PRODUCT CHANGE NOTICE

PCN # SIM2070-001

SIM2070-6-x-30-00-A

**Description of Changes**

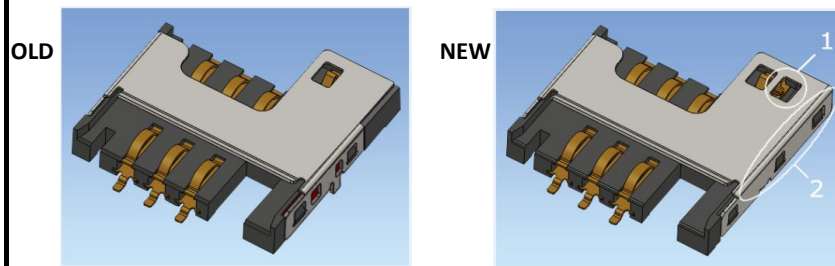
1. Changes to metal shell to accomdate amended card detection switch design.
2. Design change on card detection contacts, now with rounded contact area.
3. Metal shell extension to provide a higher strength link between the plastic insulator and metal shell.
4. SMT lead Dimension (section A-A) corrected from 14.25mm to 14.20mm, incorrect measurement on rev A drawing.

Design improvement to allow a normally closed switch option, improve performance of card detection switch pins and provide better strength between metal shell and plastic insulator. Correct SMT lead measurement.
